ADDENDUM NO. 3

**RE: NCDAC NC Correctional Institution for Women
Air Conditioning Installation
SCO ID#: 22-24913-02A
NCDAC Central Engineering Job Order # 4290**

DATE: September 12, 2023

1 VENT MODE MANUAL SWITCH INTERFACE CONTROL DETAIL (FOR AUDITORIUM)
NOT TO SCALE

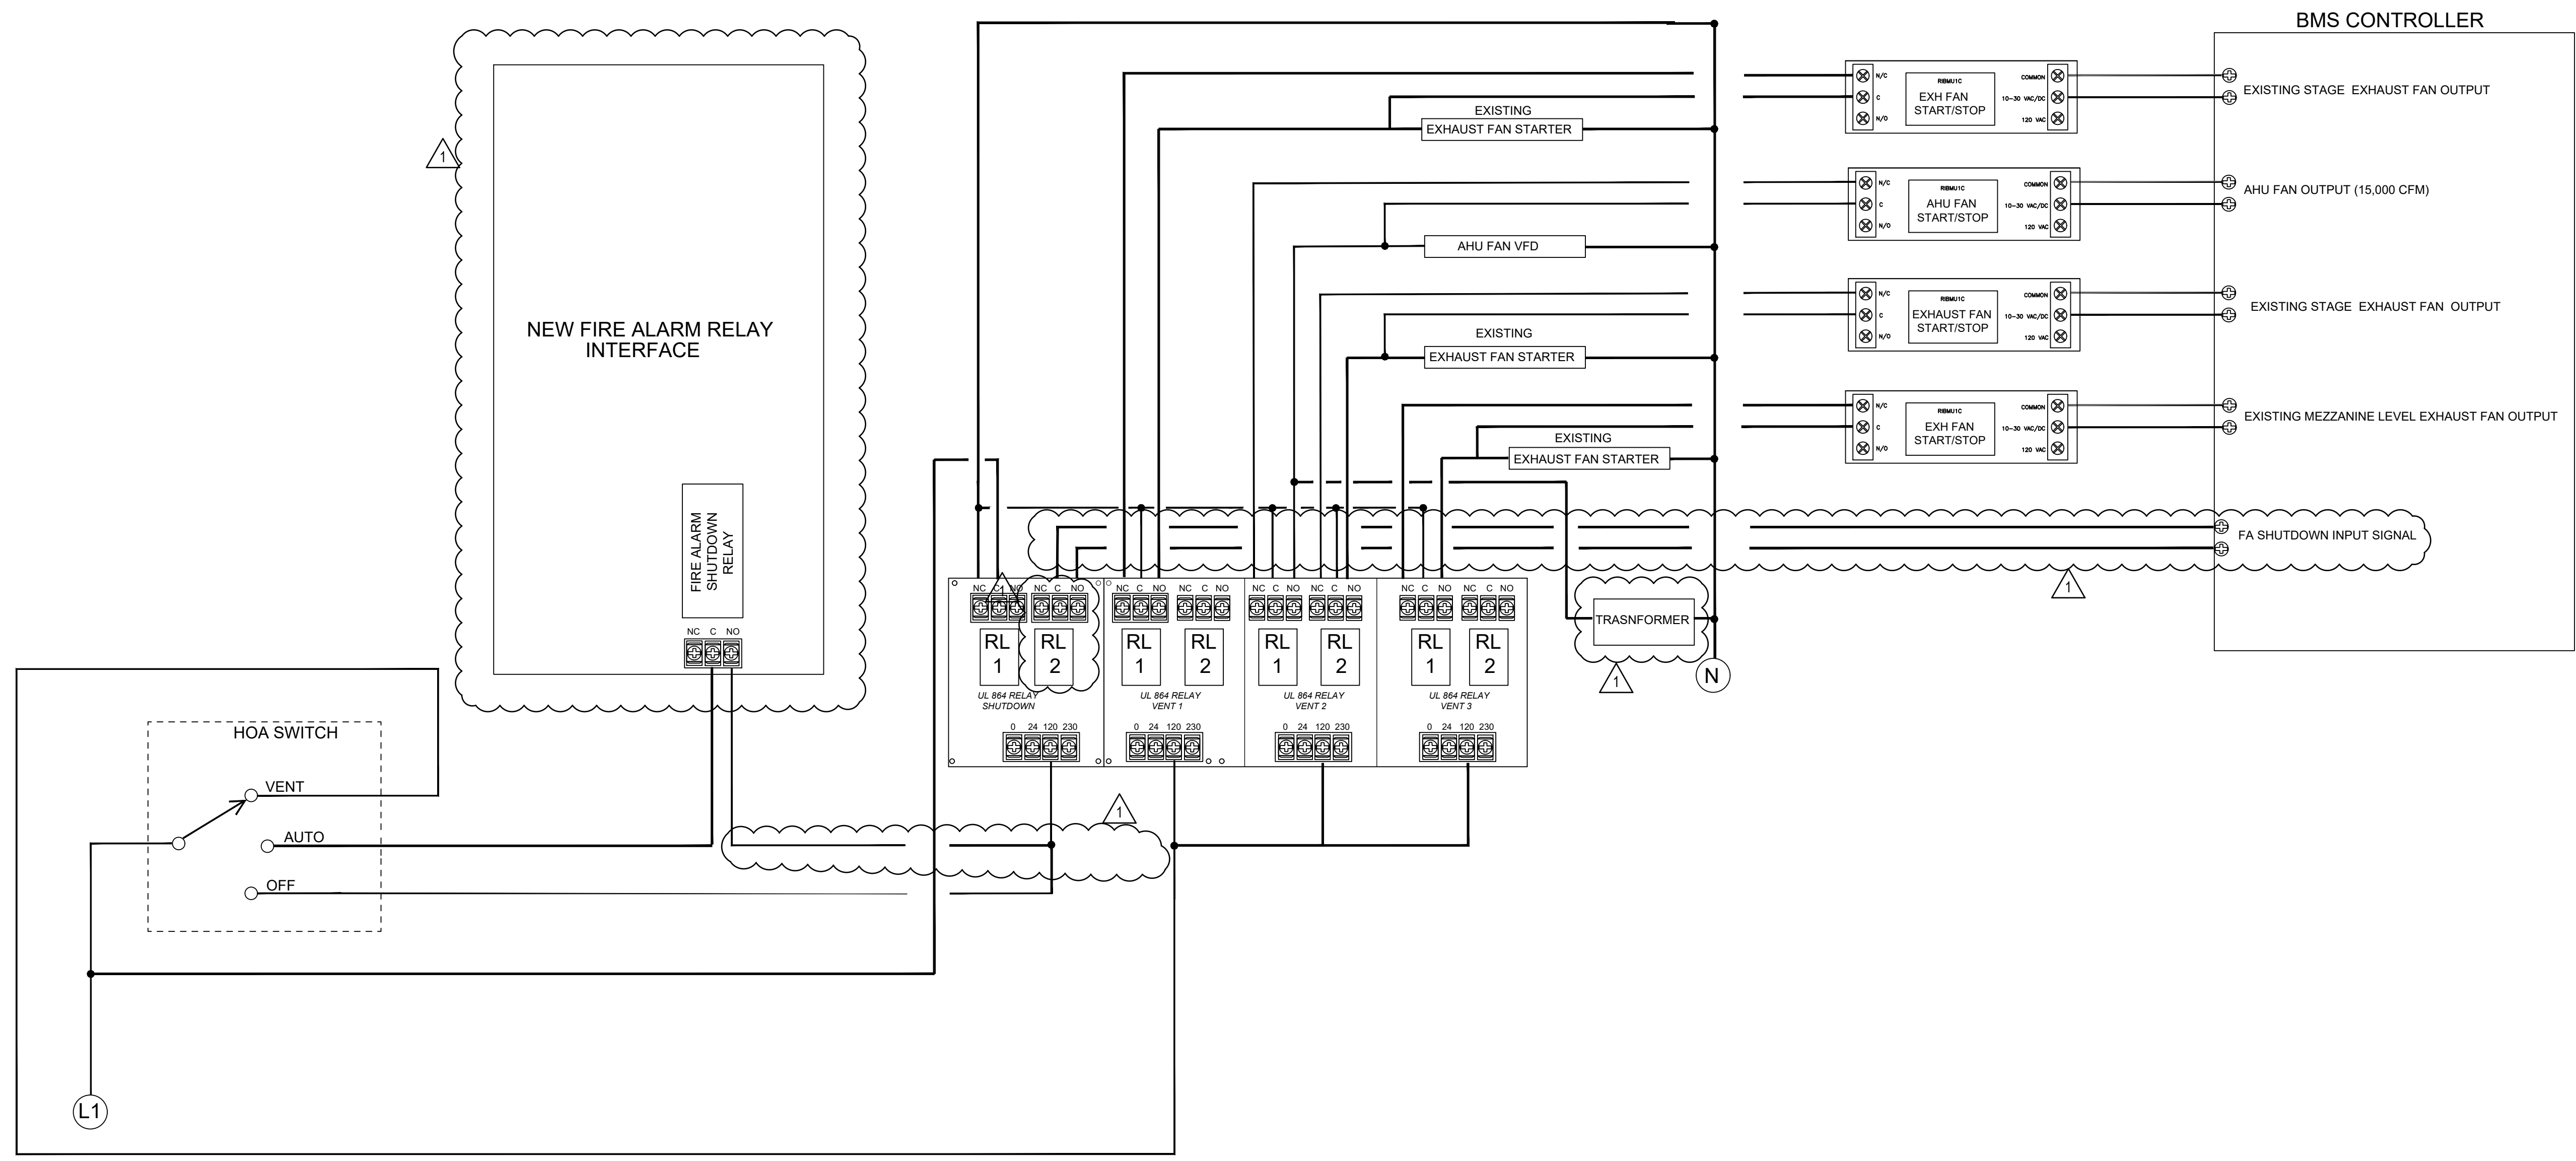
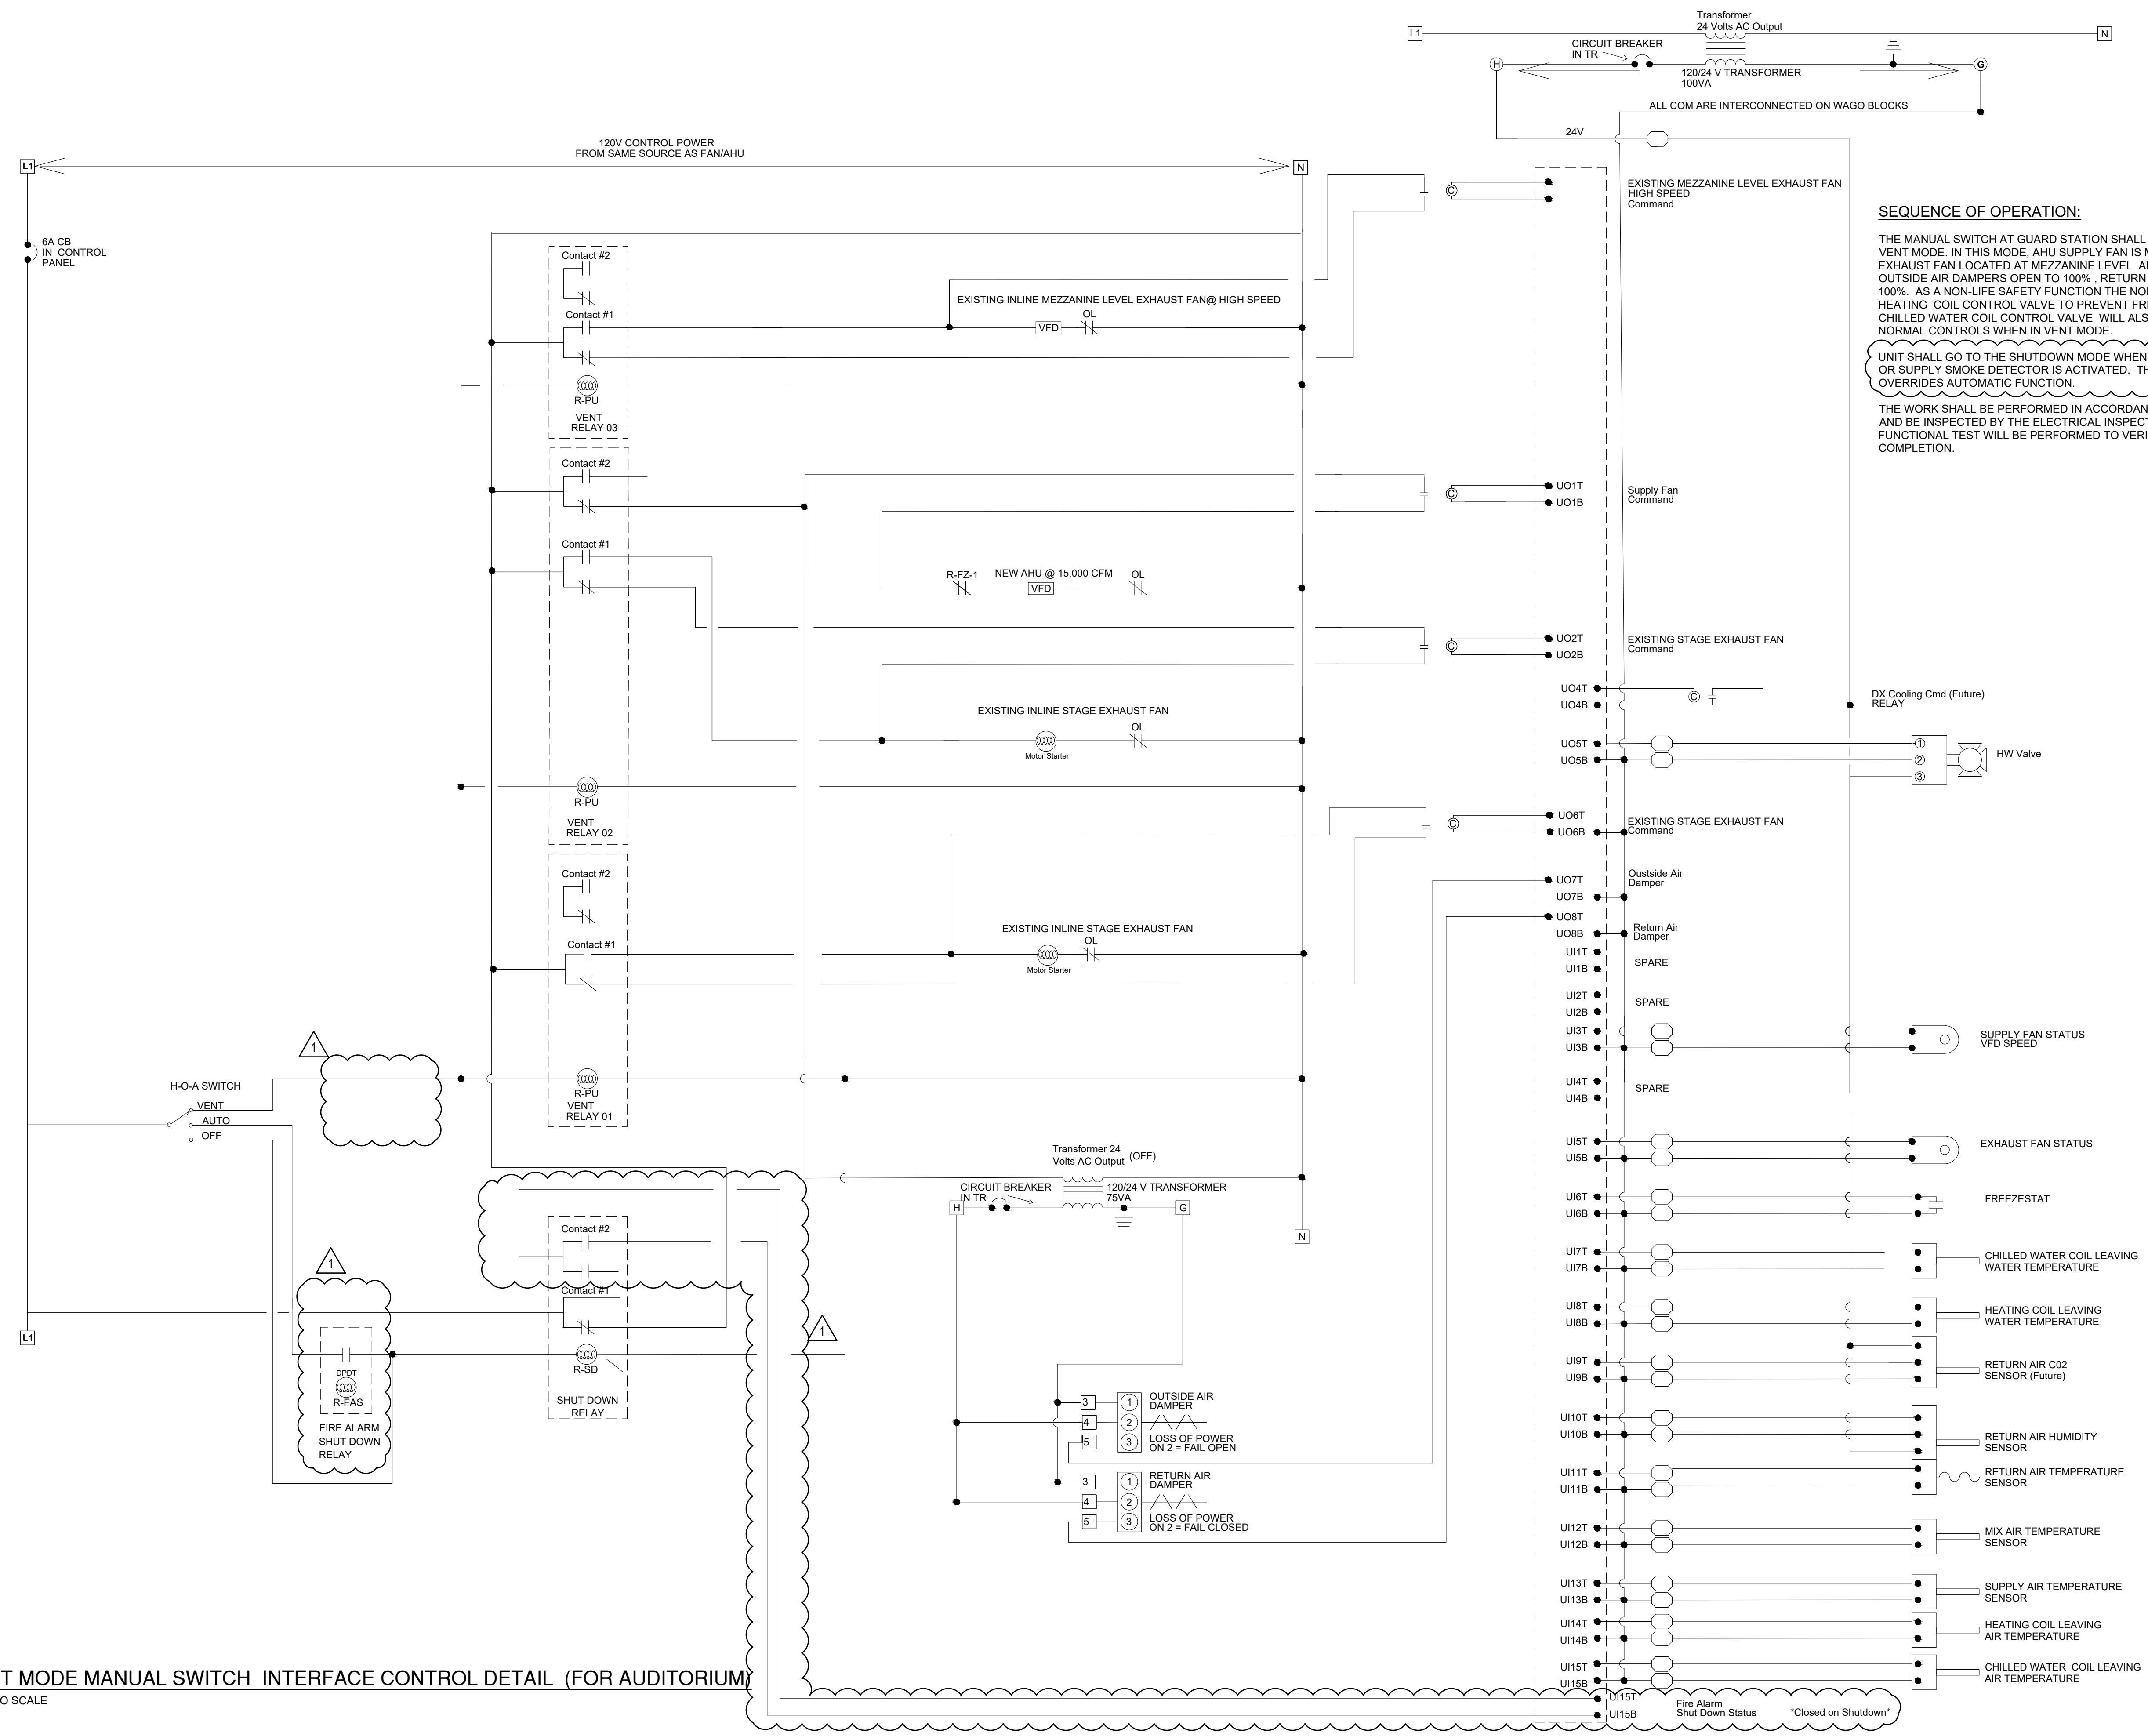
14. Sheet M605: See revisions on attached sheet.
15. Sheet M607: See revisions on attached sheet.
16. Sheet M608: Revise sequence of operation. See revisions on attached sheet.

THE MANUAL SWITCH AT GUARD STATION SHALL BE USED TO RUN THE UNIT IN VENT MODE. IN THIS MODE, AHU SUPPLY FAN IS MODULATED TO 15,000 CFM, EXHAUST FAN LOCATED AT MEZZANINE LEVEL AND STAGE SHALL BE ENERGIZED. OUTSIDE AIR DAMPERS OPEN TO 100%. RETURN AIR DAMPERS SHALL BE CLOSED 100%. AS A NON-LIFE SAFETY FUNCTION THE NORMAL CONTROLS WILL OPEN THE HEATING COIL CONTROL VALVE TO PREVENT FREEZING IN VENT MODE. THE CHILLED WATER COIL CONTROL VALVE WILL ALSO BE TURNED OFF BY THE NORMAL CONTROLS WHEN IN VENT MODE.

UNIT SHALL GO TO THE SHUTDOWN MODE WHEN THE RETURN AIR DUCT OR AREA OR SUPPLY SMOKE DETECTOR IS ACTIVATED. THE MANUAL HOA SWITCH OVERRIDES AUTOMATIC FUNCTION.
